LZ210 - Bug #731

power system

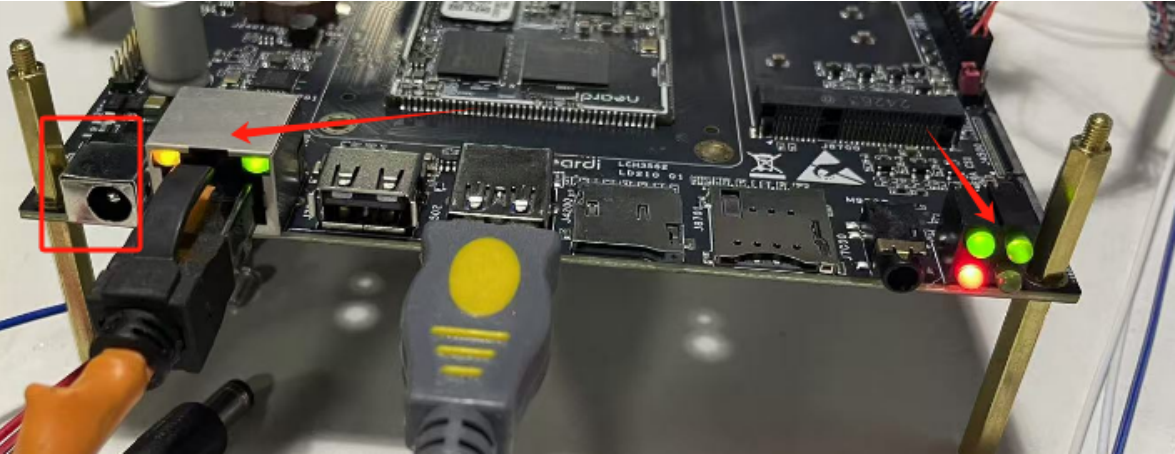
usb3.0
usb3.0
system
usb3.0power system

R2006470KDCDC 5.5V
